Rezoning Transportation Analysis

Petition Number: 2026-014

Date	Description
06-25-26	First Review (ME)

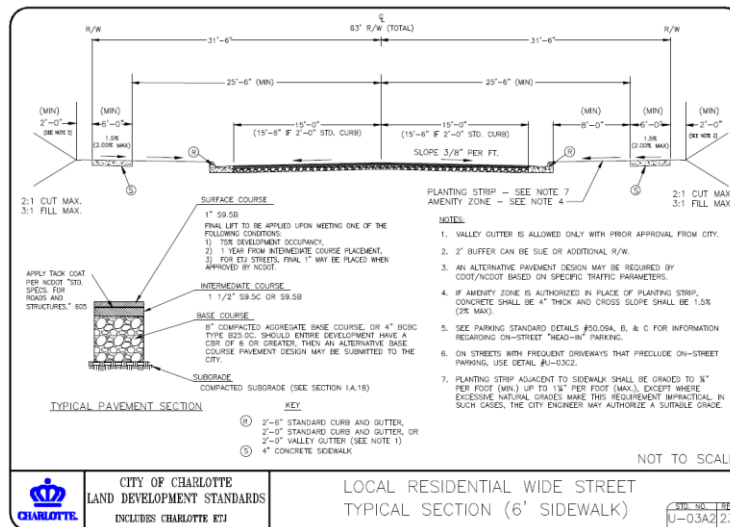
1. Curblines:

- Dearmon Road:** Location of curb and gutter to be installed to 27 feet from the roadway centerline to accommodate Charlotte Streets Map to match the typical section shown below.

Label and dimension the curb and gutter from the centerline for each road on the site plan.
